ADEQUACY OF STATION ELECTRIC DISTRIBUTION SYSTEM

VOLTAGES, ZION STATION, UNIT 1, DOCKET NO. 50-295,

TAC NO. 13007

INTERIM REPORT

ZION STATION
UNIT ONE LINE DIAGRAM
FIGURE 1

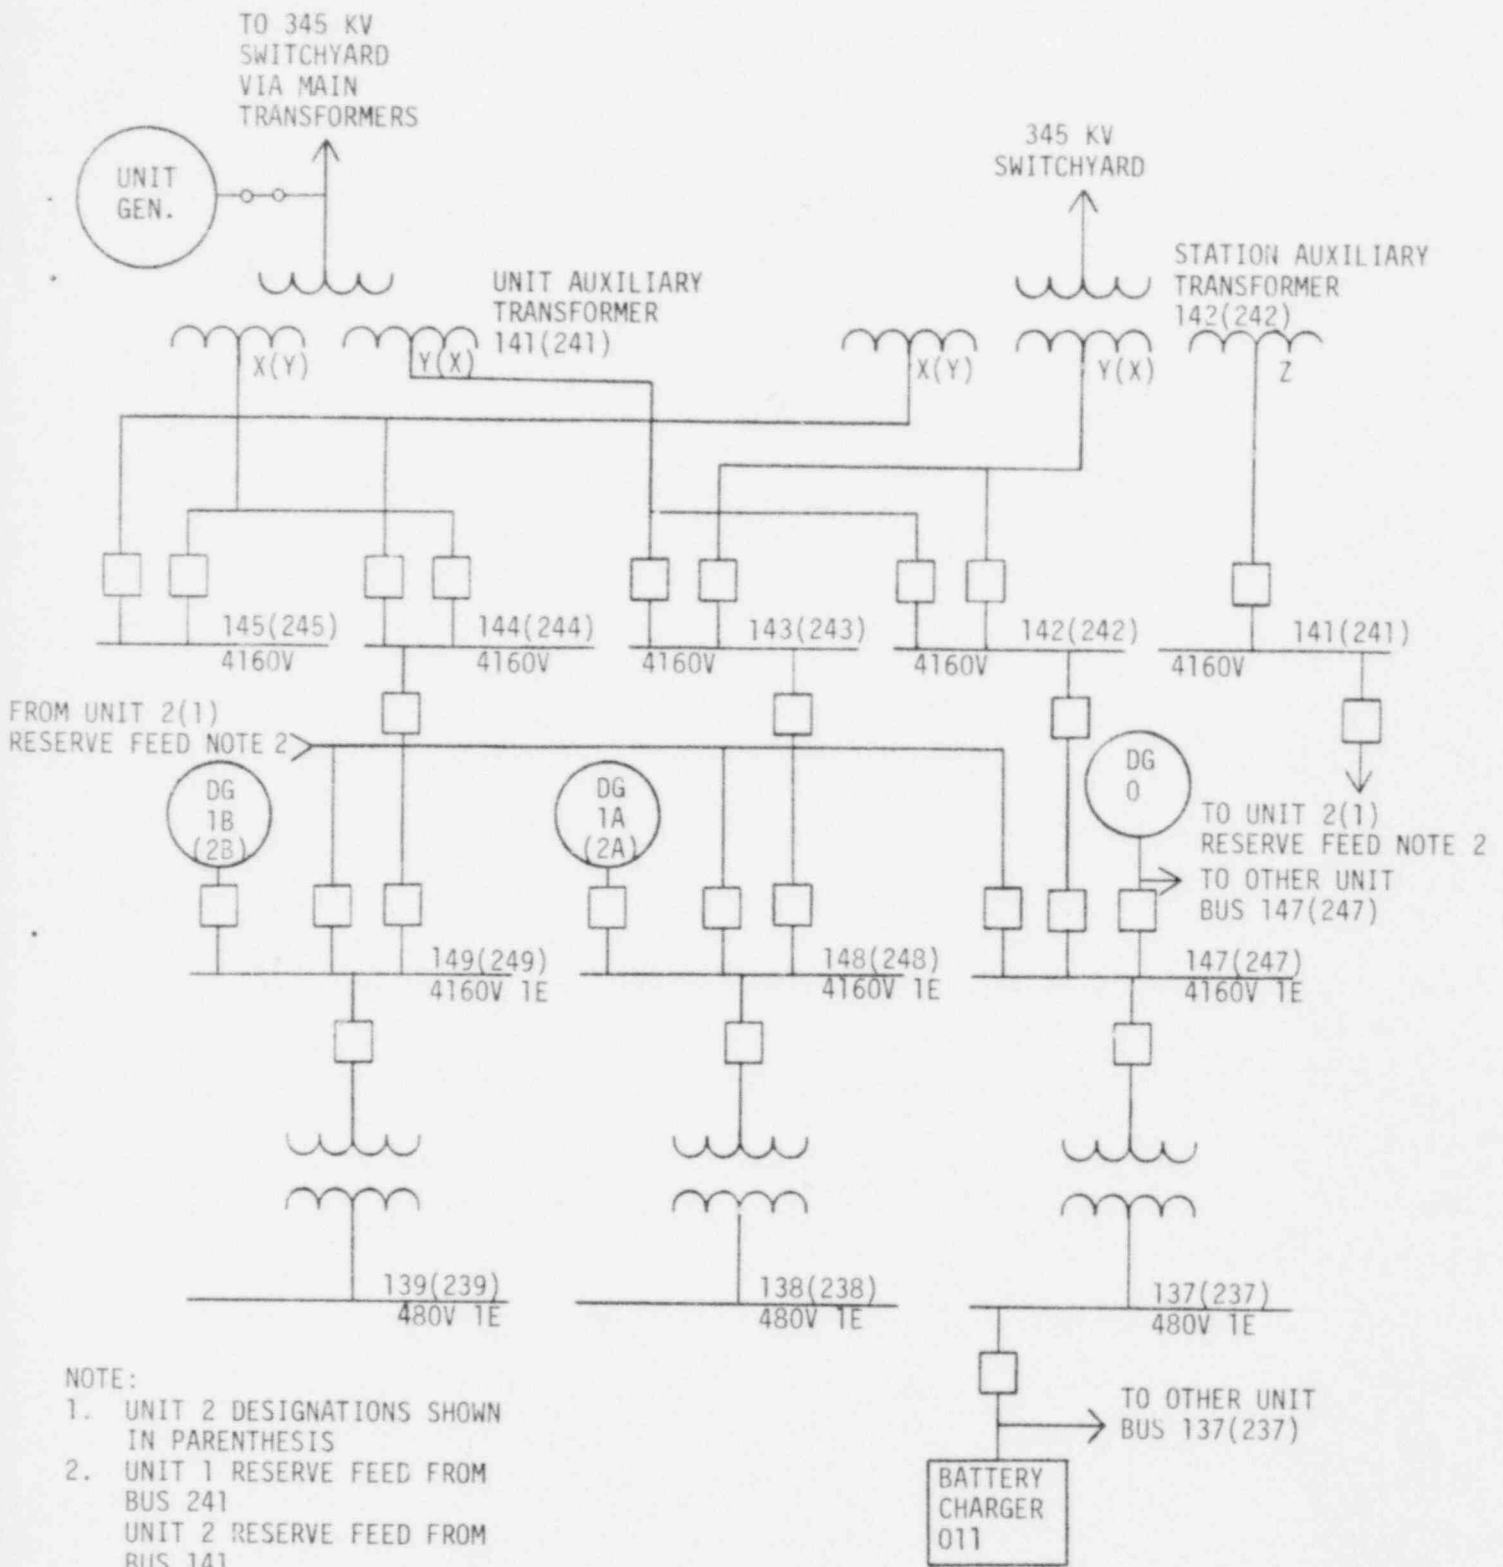
Figure 1 shows that, for Unit 1, the class 1E 4160V buses 147, 148, and 149 are normally supplied power from auxiliary buses 142, 143, and 144, respectively. These three buses are connected via two station auxiliary transformer (SAT) secondary windings (a single transformer) to the 345kV switchyard. The Unit 2 distribution system is identical except for bus and transformer numbers.

The CECO analysis shows that one of the three class 1E 4160V buses can be energized from the other unit SAT Z winding via an inter-tie connection that serves as a reserve source. The various breakers feeding each bus are interlocked so that no two sources can be connected together.³ However, no interlocks exist to prevent two or three class 1E 4160V buses from being energized at the same time by the inter-tie connection.

The unit transformers are connected independently to the offsite power grid. CECo has shown that the Z winding of one SAT supplies adequate starting and operating voltages to one of the three 4160V class 1E buses of the other unit if the administrative procedure prohibiting the start of the electric steam generator feedwater pump is followed. CECo has not shown that more than one bus can be powered by this inter-tie.

1. CECo has not provided voltage analysis for the Z winding of one unit SAT supplying power to more than one class 1E power system of the other unit, CECo should put limiting conditions of operation in the Zion Technical Specifications to prevent the inter-tie from powering more than a single 150V class 1E bus. Alternatively, CECo could provide appropriate interlocking.
